Spoken Testimony on 145th Street Station Subarea DEIS Addendum

Attachment J - Comments on Addendum to DEIS

Subject: Additional Comment on 145th Addendum to DEIS

Figure 3: Thornton Creek Sub-Basins-

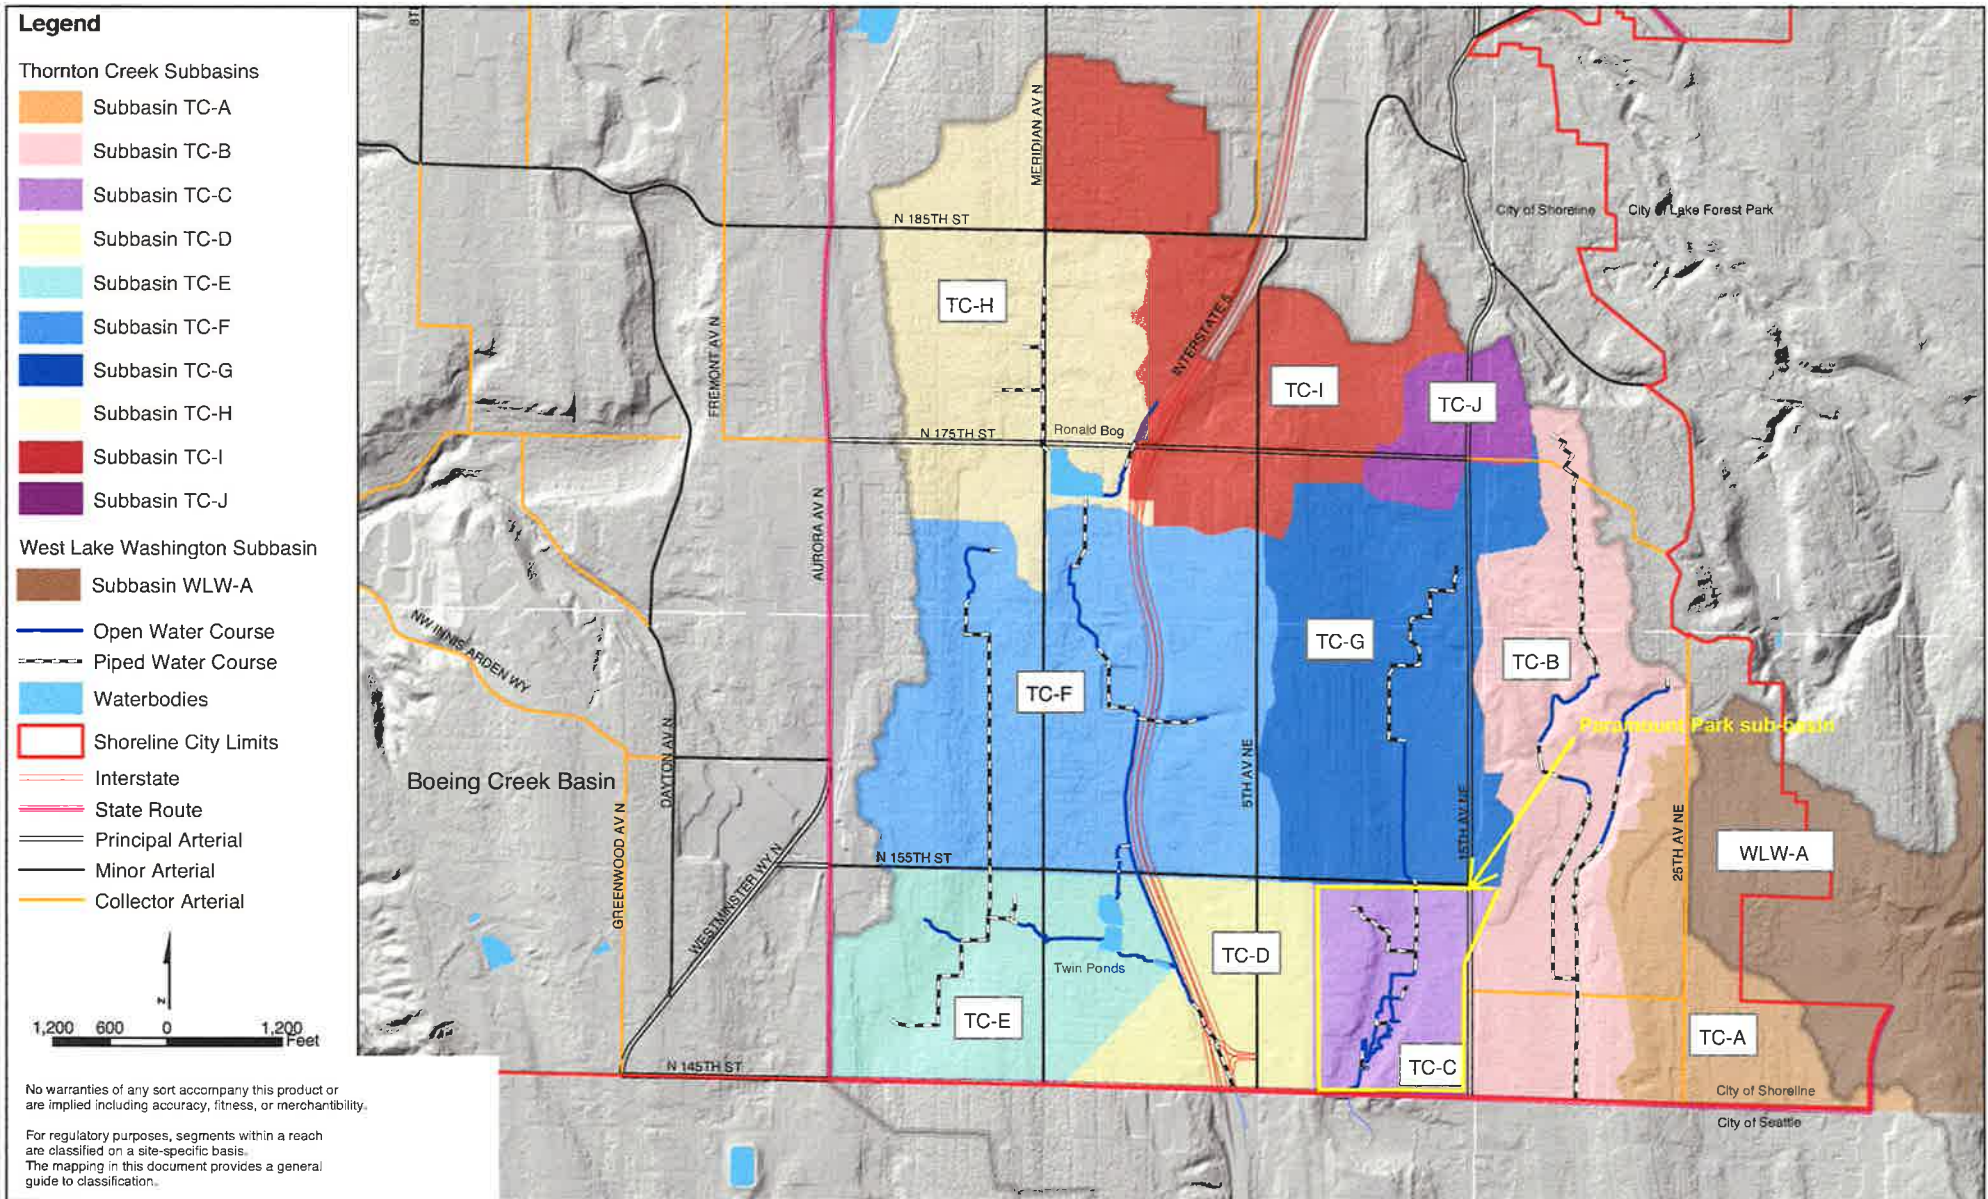
Little's Creek (Subbasin TC-C – Figure 3) flows through Paramount Open Space through segment TC14 mapped on Figure 5 as a tributary to Thornton Creek. The aerial photograph evidence documented in the City's Thornton Creek Characterization Report states that it flowed to Jackson Park in an open stream prior to the 1940's (Tetra Tech 2004). Much of this Creek has been piped from residences west of NE 174th Street and 14th Ave NE with another tributary that is now also flowing from a culvert. Beginning at 12th Ave NE, the creek (Figures 5 and 6) come out of a pipe and flow west to the Park and then jog south where the tributary splits into two. The western arm, which is the main channel of Little's

In 2004 the drainage study evaluated the total impervious areas in subdrainage TC-C to be 45 percent (Tetra-Tech, Thornton Creek Characterization Report, Figure 3). The future build-out of the subdrainage projected an increase to 50 percent impervious if the zoning stayed the same at R-6. Changes from a R-6 zoning to the proposed MUR-30 and MUR40 and MUR 70 proposed adjacent to the Park will increase the amount of impervious surface up to 90 percent with the equivalent of 48 units/acre and 75 percent with 18 units per acre (Tetra Tech 2005 Table 2-3). This increased impervious surface would be associated with increase surface flow in streams post-storm event. The Tetra Tech report also states that it could "result in flooding and destroy aquatic and riparian habitat by eroding banks, and removing the riparian (stream-adjacent) vegetation".

Figure 5: Twin Ponds and Paramount Park Wetlands and Streams

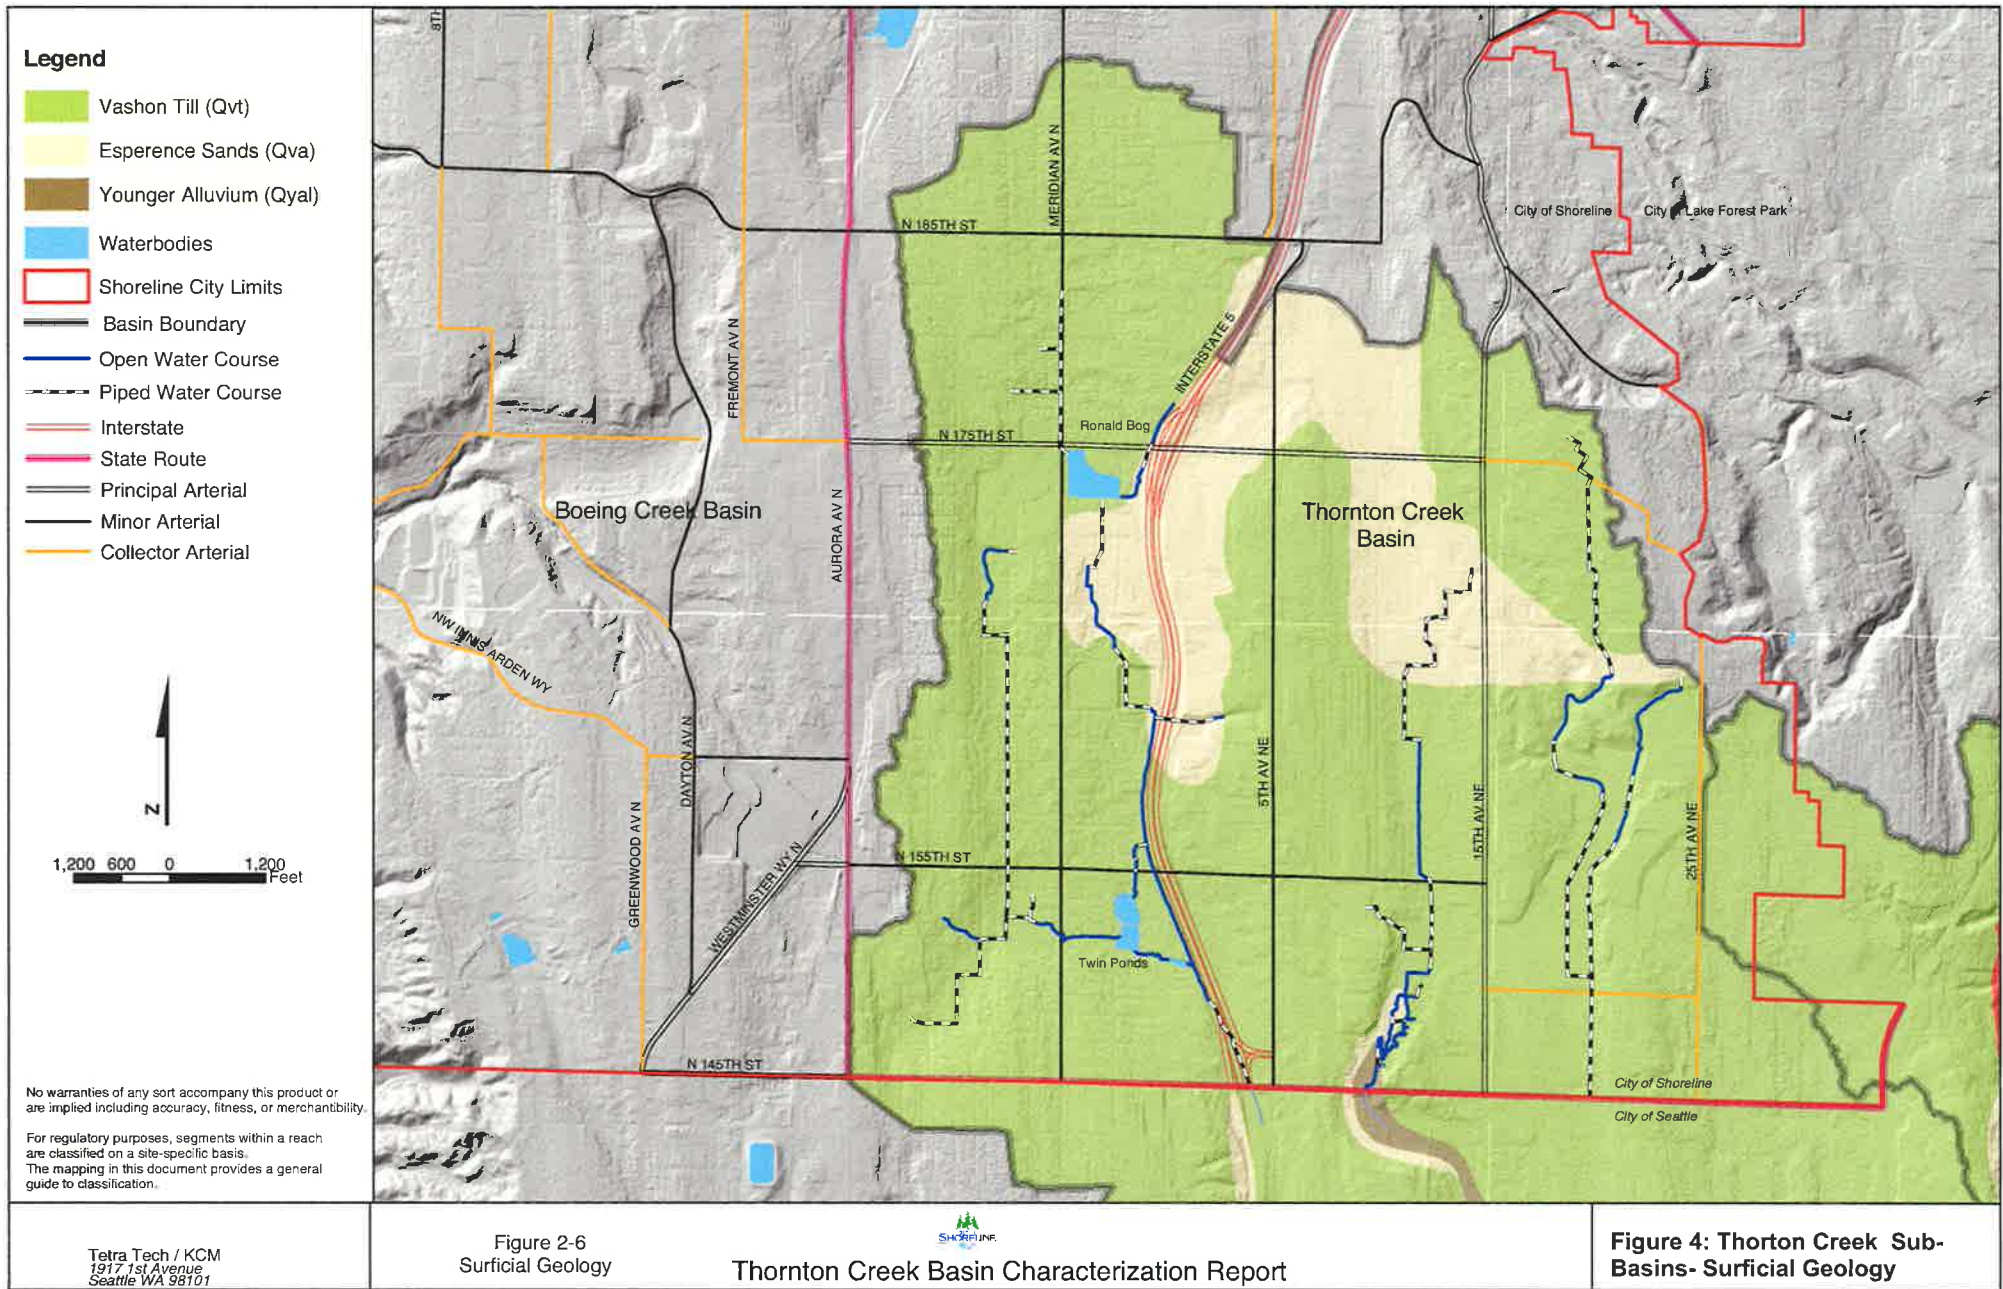
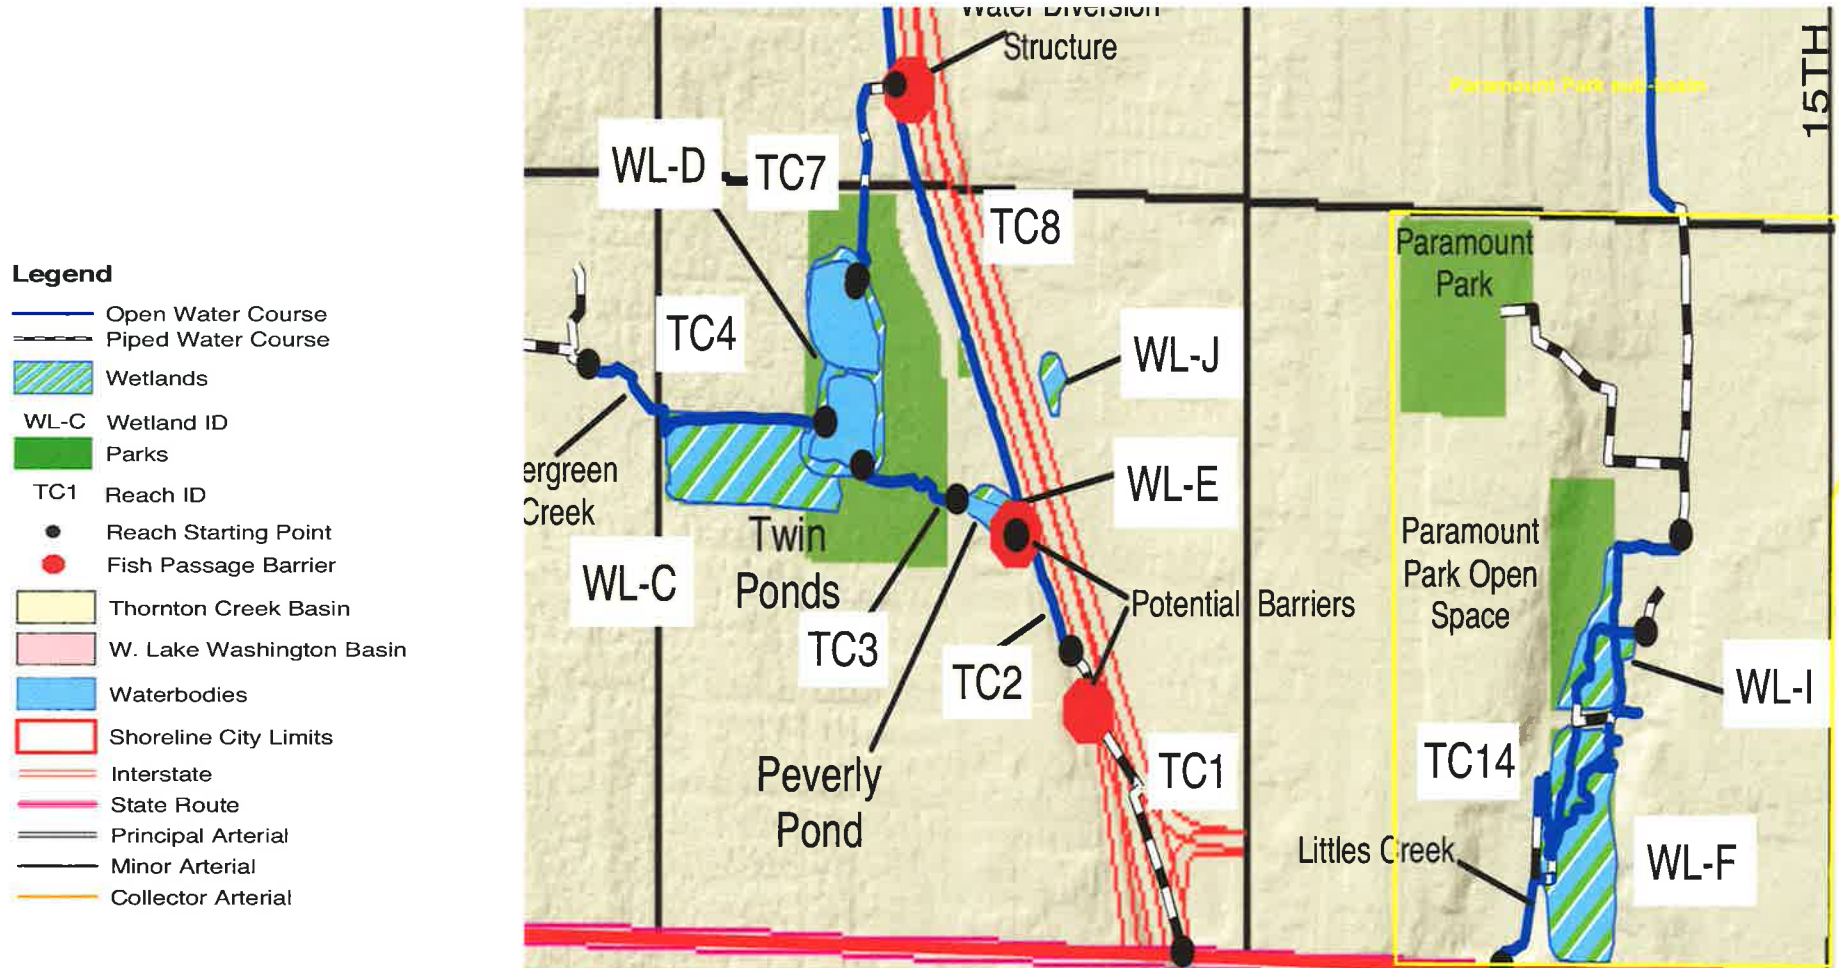
The two ponds and associated Wetland WL-F on Figure 5 were enhanced and/or constructed by local volunteers under a Water Quality Block Grant awarded by King county Department of Natural Resources prior to the 2004 basin characterization report. These areas are now well established and the plantings installed back in the early 2000's are now well established. Photos on photo sheet 6 of the attached photos show some examples of this area.

Creek, flows through Wetland WL-1 (2004 inventory, Figure 5) and a drainage tract with landscaping; and the eastern arm flows through on the edge of Wetland WL-L and through Wetland WL-F (also Figure 5 where it enters the pond and wetland enhancement area identified above supplying the wetlands, seeps back into the second pond via small channels described above and then flows west into the main channel of Littles Creek. The stream through the Park is generally still in good condition with sufficient bank vegetation and sparse armoring and fair pool frequency. Gravel and quarry spall is present in the south end of the reach but overall this segment is the ONLY one of the three segments of Thornton Creek within the City of Shoreline that was given a "fair" rating when assessed (Tetra Tech 2005). It is imperative that the City do all it can to maintain the integrity of these tributaries should the new zoning become reality. Increasing residence density on the east side of the Park would be in the direct path of many of these channels and no additional piping should be allowed. It should be noted that the DEIS states that Littles Creek lies ½ mile from the Proposed Light Rail Station, but actually it is only ¼ of a mile.

Figure 6: Paramount Park Wetlands and Streams Mapping. City of Shoreline GIS 2016.

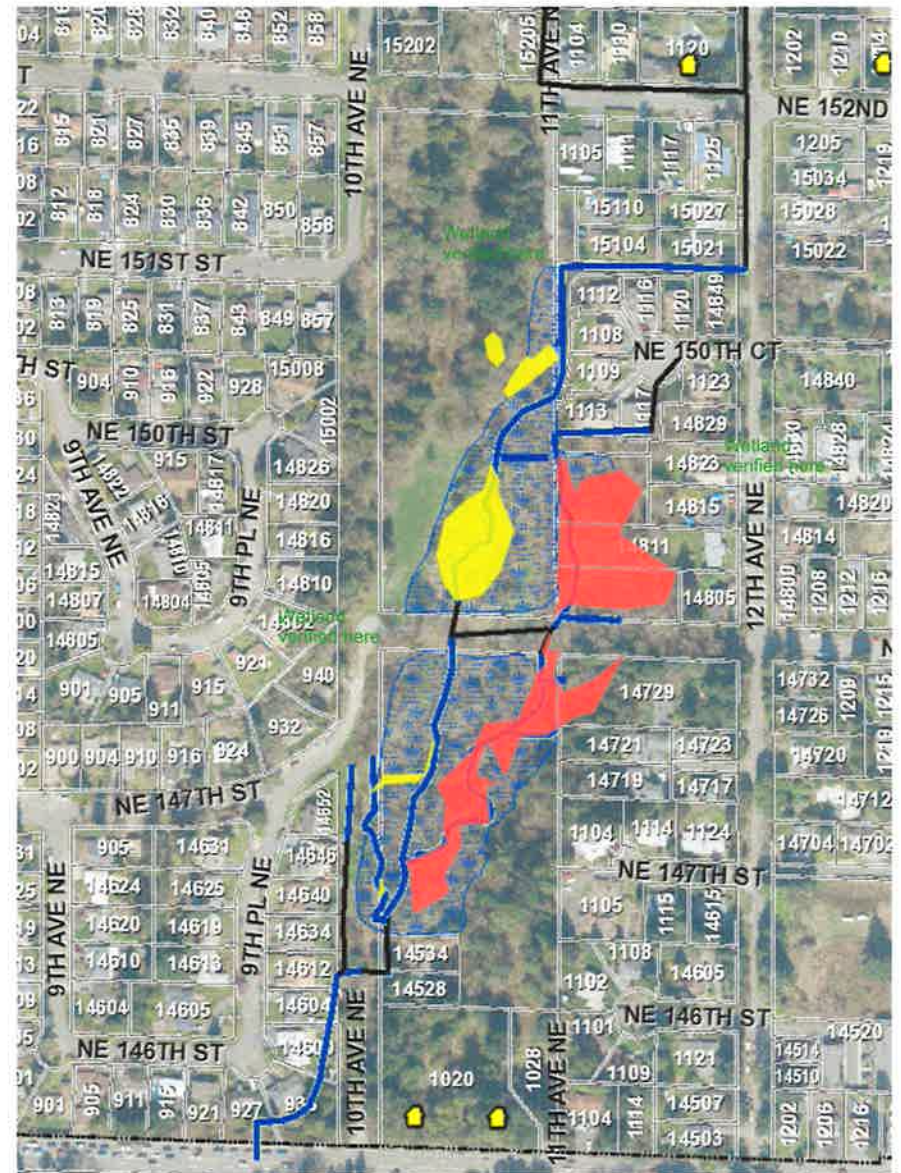
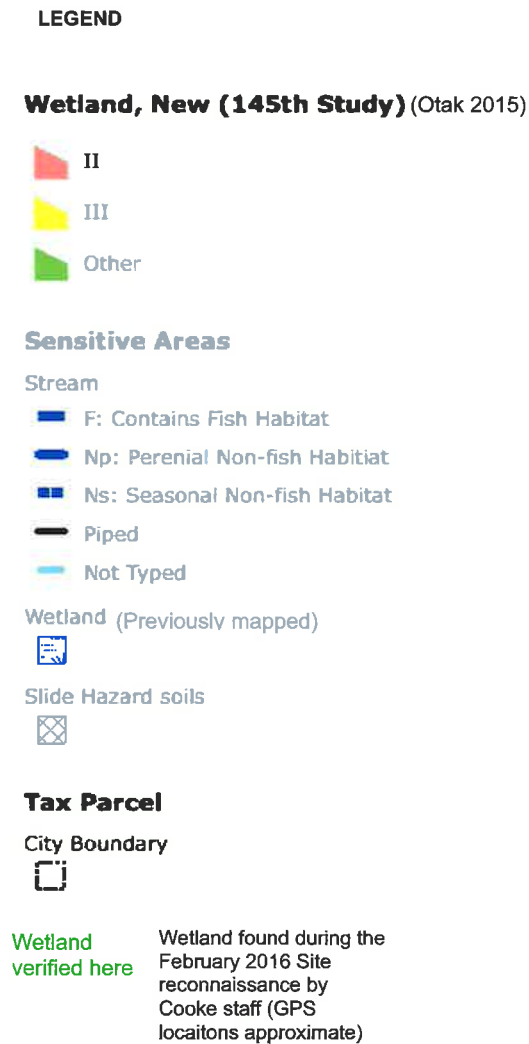
part of the park, (Figure 6 arrows showing where additional wetland was found; Figure 8 photo map and Photos 21-25). We also found more wetland in the northeast corner of the Park and associated residences that are not shown on the Otak map (Figure 6 arrows showing where additional wetland was found; Figure 8 photo map and Photos 1-10). And more wetland in the central part of the park between Wetland F and Wetland C such that these two wetlands are actually one wetland system (Photos P1, P2, P18, and P19). Additionally, many of the residences on the east side of the Park along 12th Avenue NE had wetland continuing into their western back yards abutting the Park (Figure 6 arrows showing where additional wetland was found; Figure 8 photo map and Photos 12-20). Much of this area was also not included as wetlands mapped by Otak. Approximate GPS locations of wetlands found during our February reconnaissance are shown on Figure 8 where the photo pins are located and on Figure 6 where the arrow points indicate locations where both photos and GPS points were taken in areas that were wetlands. The arrows shown on Map 6 do not show a formal delineation map. It is indicating areas that met wetland criteria and which were not identified on the Otak map as being wetland. A word about the photos included: The photos show characteristics about the ground conditions – either the vegetation prevalent (which is usually wetland species for the wetland shots) or the soils conditions (again showing wetland soils), or standing water indicating the area has wetland hydrology. When the shots are of upland they indicate this.

The Otak reconnaissance wetland map is also displayed as a layer on the City's Wetland map as a layer that is shown as either a blue or yellow polygon/series of polygons on Figure 6. as the with Wetland III having a much reduced footprint of wetland WL-I and the red pattern with a much reduced footprint over the previous delineation also shown as the blue shaded pattern on Figure 6.

The drainages (streams and creeks) mapped in the Park by Otak (Figures 6 and 7) include some omissions that have been added back as the black lines on the City's GIS database (Figure 6). We observed these creeks/drainages are still present when we performed our reconnaissance on January 29th, 2016 (Photos P8, P9, P11, P17, P20, P23, P24, P21, and P25). Little's Creek is the main tributary to Thornton Creek through the park but there are many other tributaries, wetlands, ponds and connecting channels that are also present (See Figures 5 and 6). Some of the channels are now piped, especially the main channel that passes through a culvert under the gravel road the bisects the Park from north to south (photo P17).

We would also note that Figure AW-1 in OTAK's report, "Critical Areas – Paramount Park," does not, in fact, seem to substantiate the report's claim that there are currently structures actually located in the wetlands that extend out from the park. Certainly no houses appear to be in the wetlands. There are six houses along 12th Avenue Northeast that are within wetland buffers, but in five of these cases all or essentially all of the parcel is inside the buffer and in the other case far too little of the parcel is outside the buffer to be developable. This means that reasonable use requirements would almost certainly still
